SERVICE BULLETIN

№ 189-375

ATA 62 - MR SPLITTED SWASHPLATE BOOT REPLACEMENT

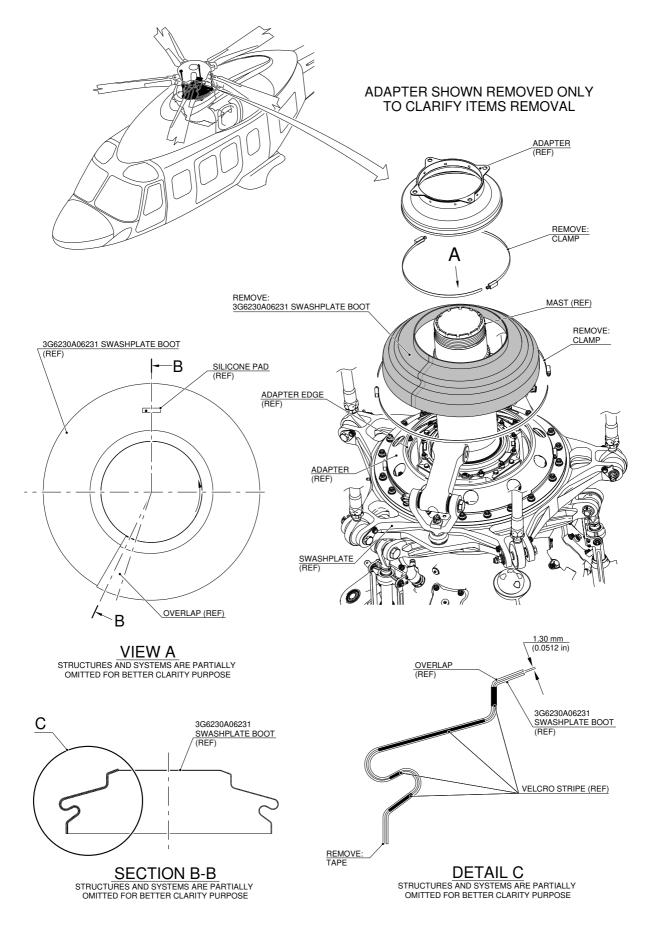
- The main rotor head should be already removed from the helicopter.
- The MR boot P/N can be found on a raised silicone pad as shown in Figure 1 View A.

- 2. In accordance with AMP DM 89-A-06-41-00-00A-010A-A and with reference to Figure 1, get access to the MR swashplate boot area. Take a picture of the MR boot splitted installation with P/N in view to add to MMIR. Remove the boot P/N 3G6230A06231 in accordance with the following procedure:

- 2.1 In accordance with applicable steps of AMP DM 89-A-62-31-03-00A-520A-A and with reference to Figure 1, cut and remove the safety wire from the upper clamp. Discard the wire. Remove the clamp that attaches the swashplate boot to the adapter assy P/N 4F6230A03131.

- 2.2 In accordance with AMP DM 89-A-62-31-03-00A-520A-A, remove the adapter assy P/N 4F6230A03131.
 - 2.3 With reference to Figure 1, cut and remove the safety wire from the lower clamp. Discard the wire. Remove the clamp that attaches the swashplate boot swashplate.

- 2.4 With reference to Figure 1 Detail C, remove the tape and lift the overlap from the swashplate boot. Use a plastic scraper to get an aid to remove the adhesive from the overlap also in the area of the velcro stripes. Lift the overlap until the velcro stripes disconnect.

- 2.5 With reference to Figure 1, carefully remove the swashplate boot P/N 3G6230A06231 from the swashplate. Use a plastic scraper to help you remove the sealant that bonds the swashplate boot to the adapter. Discard the swashplate boot P/N 3G6230A06231.
- 3. In accordance with AMP DM 89-A-62-31-04-00A-720A-A, install the swashplate boot P/N 3G6230V00251.
- 4. Return the helicopter to flight configuration and record for compliance with this Service Bulletin on the helicopter logbook.
- 5. Gain access to My Communications section on Leonardo WebPortal and compile the "Service Bulletin Application Communication".
